From: [Kendal Harr](#)
To: [Linda Ritter](#); [Dave Osaki](#); [Joe Marine](#); [Thomas Jordal](#); [Steve Schmalz](#); [Elisabeth Lara](#); [Richard Emery](#)
Subject: Carrick Court Mixed Use Development Comments
Date: Tuesday, April 26, 2022 11:53:55 PM

It's for the Carrik Court proposal at the corner of Mukilteo Speedway and 88th Street. It's for a 122

unit development with commercial along the speedway.

RIGHT TURN CHANNELIZATION STANDARD PLAN M-5.10-03

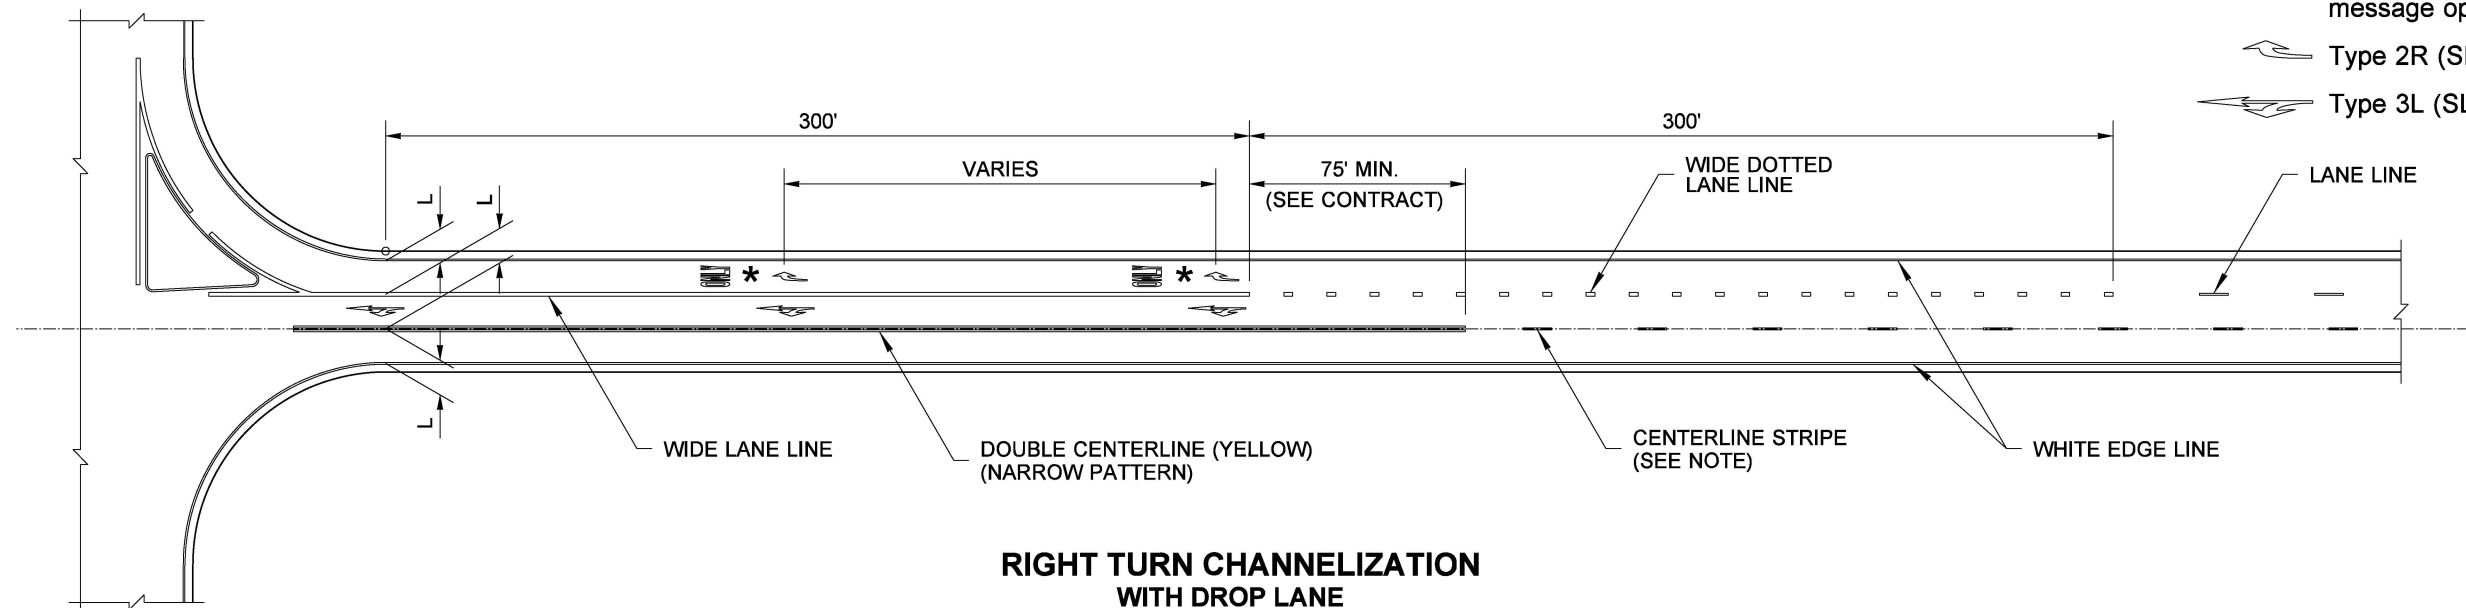
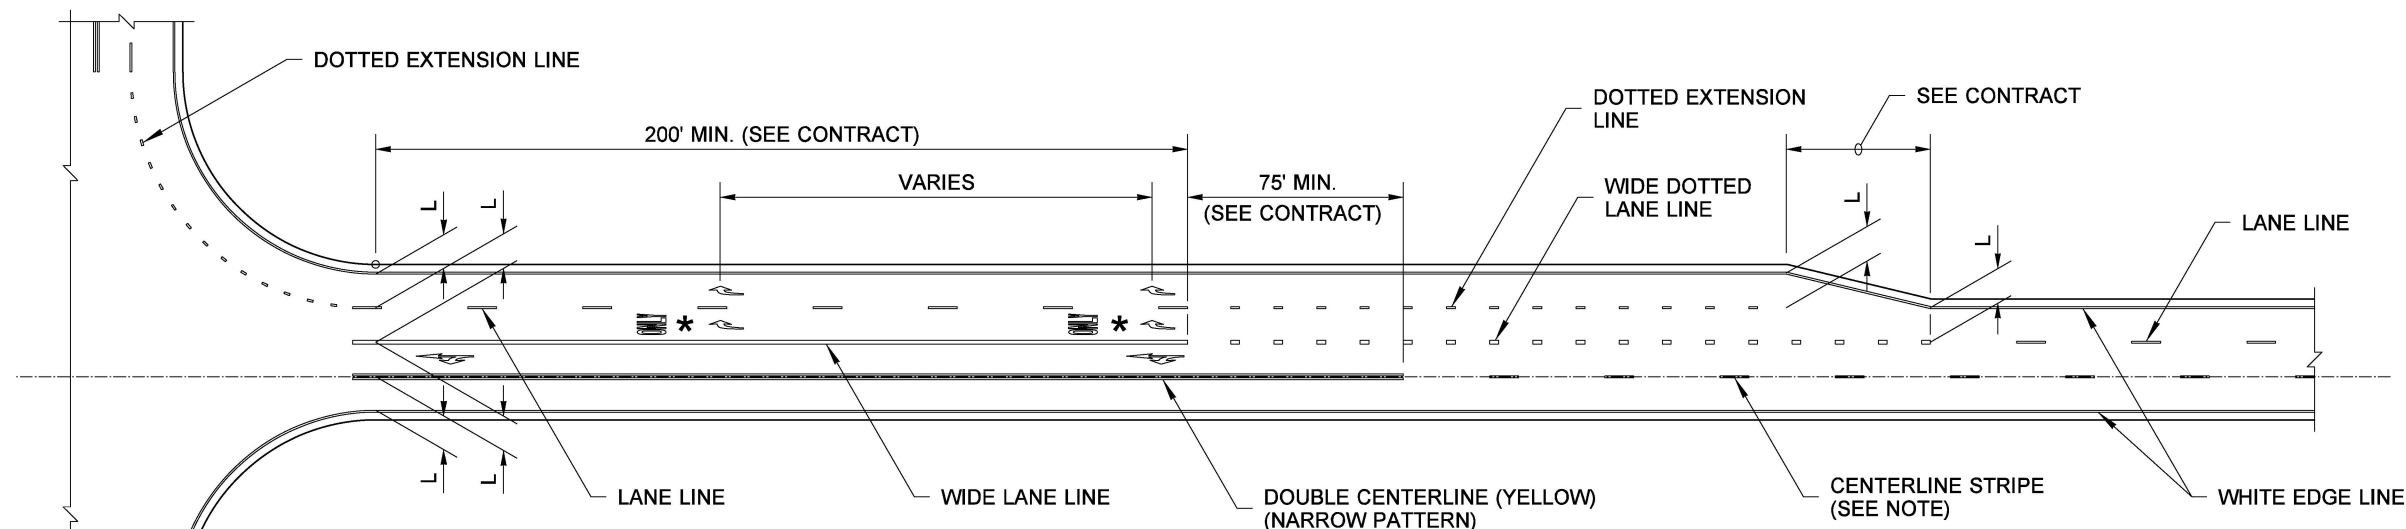
- Extend outside SB lane on SR 525 about 830' to 88th Street SW^A.
- Match existing shoulder width, which appears to be 3' from ace of curb to edge line.
- Match existing sidewalk width, which appears to be 5' from back of curb to back of sidewalk.
- WSDOT will need an approved channelization/signing plan for extending SB lane on SR 525. We request two "right lane must turn right" signs

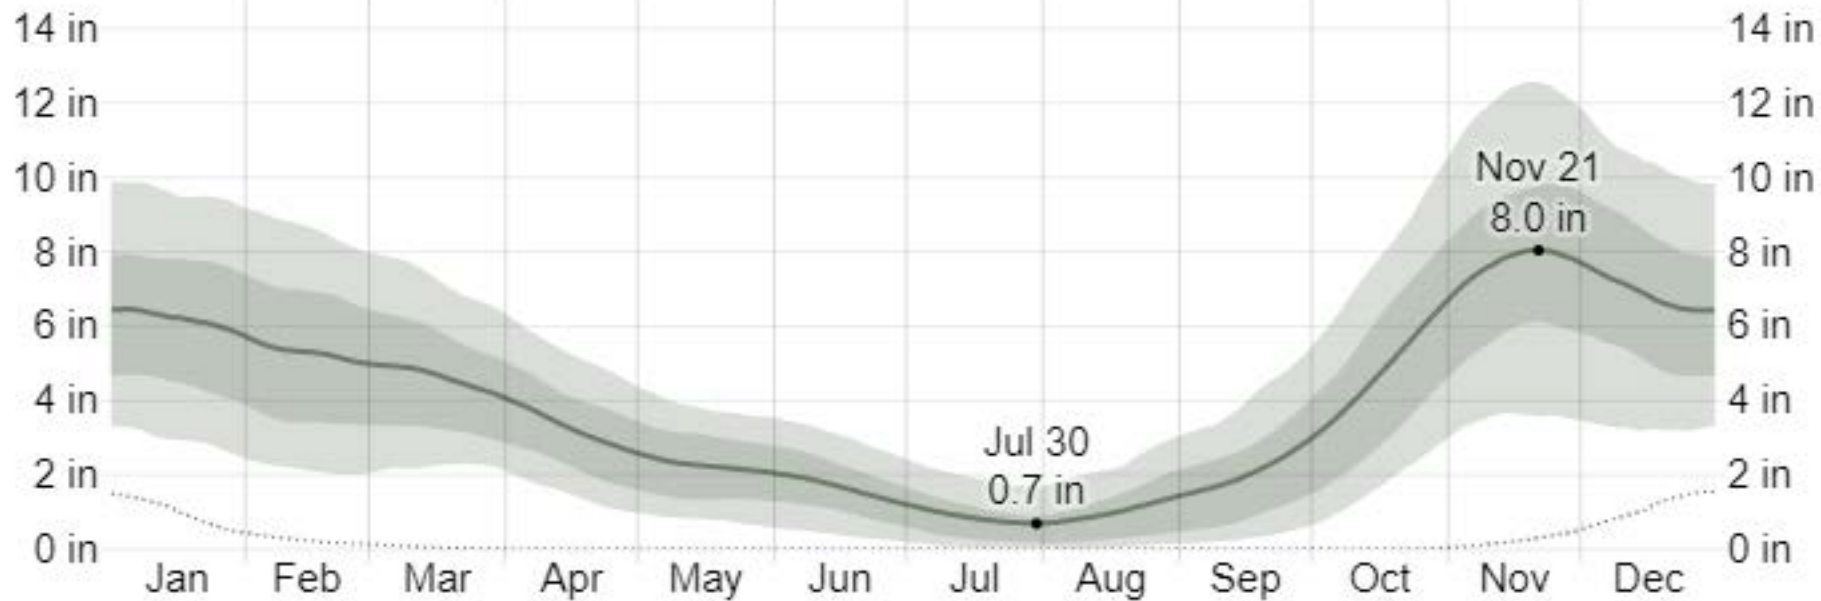
A more meaningful representation of the impact of the stormwater drainage requirement can be addressed by the available published monthly rainfall totals per the accompanying attachment. These totals are derived from data collected over the years 2014 - 2022 for Mukilteo, WA. The totals range from a low of 0.7" for the month of July to a high of 7.9" for the month of November.

Using the high of 7.9" of rainfall for the month of November the total in gallons works out to: 9.6 acres X 43,560 sq. ft./acre X 7.9 in./ 12 in. X 7.48 gal./cu. ft. H2O = **2,058,195. gallons / year.** A drainage system design should therefore be capable of handling, a least, this capacity a month to be effective. I hope this is taken into consideration when this project is reviewed, and the developer is held responsible for implementing such a system and any upgrades to the existing system in place to meet these conditions. I hope that this information is helpful. Bob Kalapinski / 4673 89th Place SW. 5/17.
